UNITED STATES PATENT AND TRADEMARK OFFICE

Office Action Summary	Application No. 10/561,401	Applicant(s) NAATTI ET AL.
	Examiner Juan J. Campos	Art Unit 3654

DETAILED ACTION

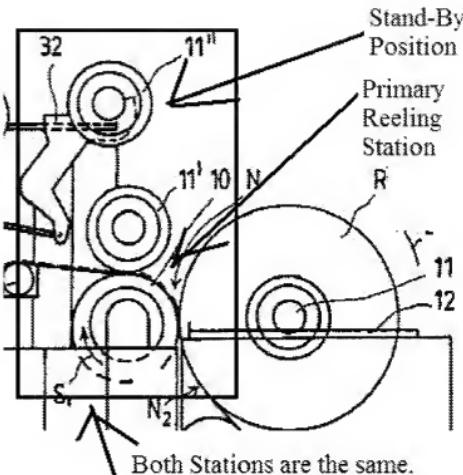
6. **Regarding claim 37 and 38,** the method comprising of reeling the paper web is discussed above in claim 34, Kinnunen et al. also shows the methods where the reeling spool is in a stationary position during the reeling in the preliminary reeling station (see figure above). Kinnunen et al. also shows the step where the new reeling spool (11) is brought to the preliminary reeling station and against the loop of the supporting member (F) with a substantially vertical linear movement (see figure above), see figures 1-5.
